ECE/TRANS/WP.29/GRRF/2007/29
14 September 2007

Regulation No. 64 (Temporary use spare wheels/tyres)

Proposal for Corrigendum 1 to the 01 series of amendments to Regulation No. 64

Model A

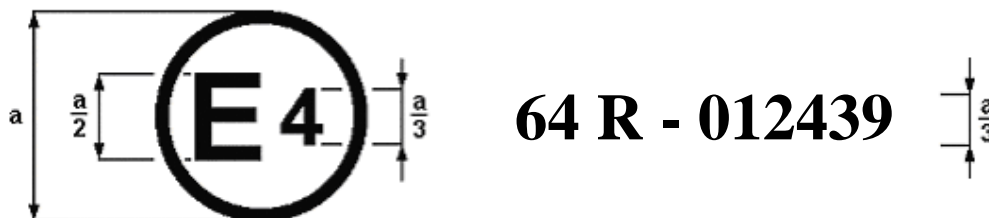
The above approval mark affixed to a vehicle shows that the vehicle type concerned has, with regard to the equipment of temporary-use spare unit(s), been approved in the Netherlands (E 4), pursuant to Regulation No. 64 under approval number **012439**. The approval number indicates that the approval was granted in accordance with the requirements of Regulation No. 64, **incorporating the 01 series of amendments**.

Model B

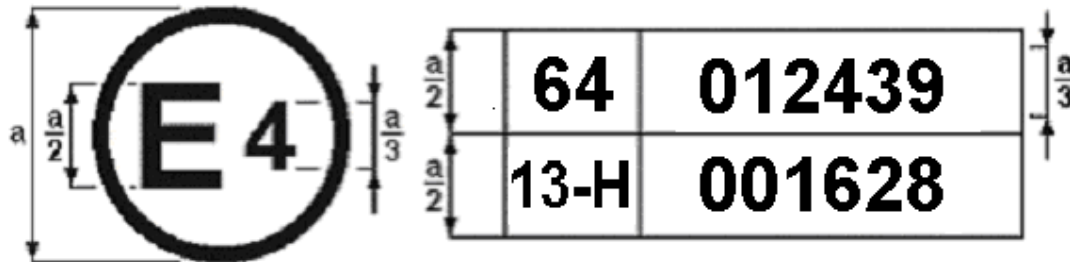
The above approval mark affixed to a vehicle shows that the vehicle type concerned has been approved in the Netherlands (E 4) pursuant to Regulations Nos. 64 and **13-H**. ^{1/} The approval numbers indicate that, at the dates when the respective approvals were given, Regulation No. 64 **included the 01 series of amendments and Regulation No. 13-H was in its original form.**
